SIB 54 03 22

BUZZING SOUND HEARD IN THE SKY LOUNGE ROOF

E-Series	Model Description	Affected Option Code
I20	iX Sports Activity Vehicle	407 Panoramic Eclipsing Roof

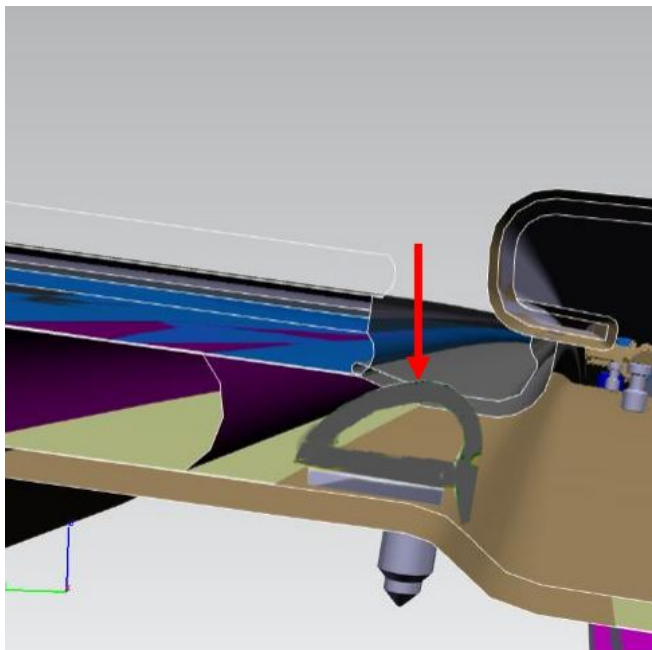
A buzzing sound is heard in the Sky lounge roof while driving at highway speeds.

At high outside temperatures, the inner roof trim seal will become soft. Therefore, causing the inner roof trim seal to flap against the Sky lounge roof while at highway speeds.

Install sunroof surrounding seal onto the Sky lounge roof frame.

1. Remove the roof trim following the repair instructions listed in ISTA/AIR (51 13 280).
2. Using surrounding seal, cut a length of **1850 mm**.
 - **2 pieces, left and right side**

3. The sunroof surrounding seal is self-adhesive. Attach seal to the Sky lounge roof frame.
